SUBJECT: PALISADES PLANT - AMENDMENT NO. 143 TO FACILITY OPERATING LICENSE
NO. DPR-20 (TAC NO. M82059)

ATTACHMENT TO LICENSE AMENDMENT NO. 143

SAFETY EVALUATION BY THE OFFICE OF NUCLEAR REACTOR REGULATION
RELATED TO AMENDMENT NO. 143 TO FACILITY OPERATING LICENSE NO. DPR-20

FIGURE 3-0

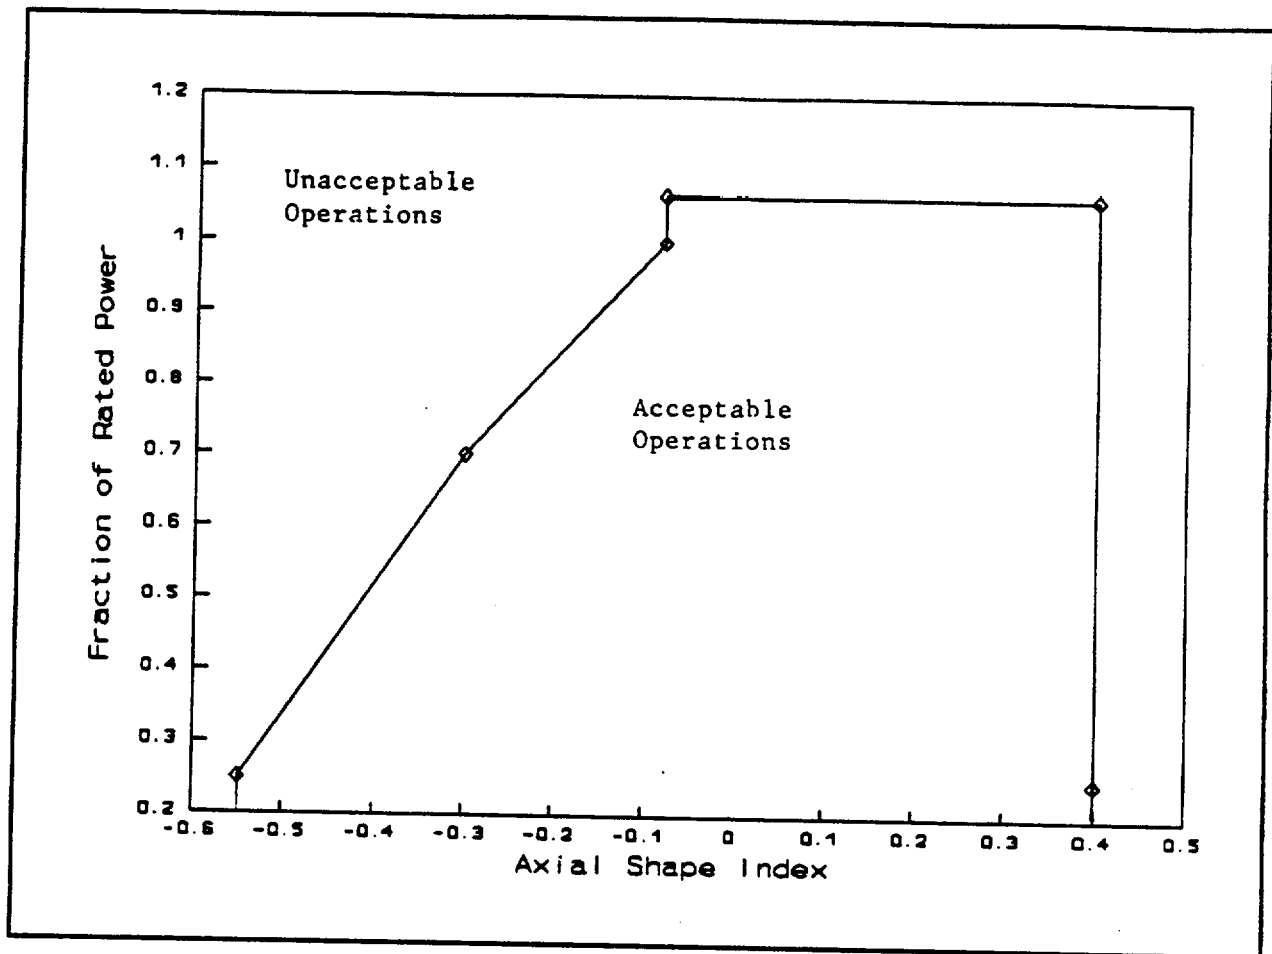
$$\begin{aligned} 1800 &\leq \text{pressure} \leq 2200 \text{ psia} \\ 100.0 \times 10^6 &\leq \text{Vessel Flow} \leq 150 \times 10^6 \text{ lb/h} \\ \text{ASI as shown in Figure 3.0} \end{aligned}$$

The Axial Shape Index alarm channel is being used to monitor the ASI to ensure that the assumed axial power profiles used in the development of the inlet temperature LCO bound measured axial power profiles. The signal representing core power (Q) is the auctioneered higher of the neutron flux power and the Delta-T power. The measured ASI calculated from the excore detector signals and adjusted for shape annealing (Y_1) and the core power constitute an ordered pair (Q, Y_1). An alarm signal is activated before the ordered pair exceed the boundaries specified in Figure 3.0.

-0.550, 0.250
-0.300, 0.700
-0.080, 1.000
-0.080, 1.065
+0.400, 1.065
+0.400, 0.250
